Access Compliance Report Public Rights-of-Way (Curb Ramps)

Main Street: MARYNELL_DR Cross Street: OLD_RANCH_RD Location: NE

ADA ID: RPAT210922082629 Ramp Type: Type 3 - Combination 1 Initial Pass/Fail: Fail Overall Compliance: No Severity Score: 4

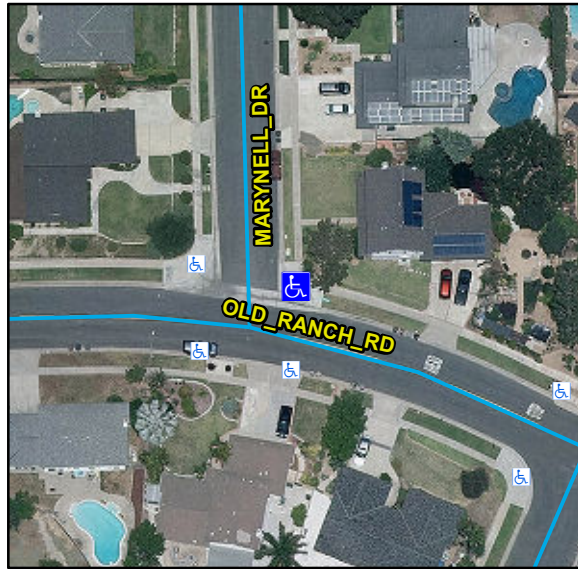
R304.2.2, R304.5.1, STD 1115

Remove & Replace Curb Ramp With Two New Directional Ramps or Equivalent. Remove & Replace Sidewalk.
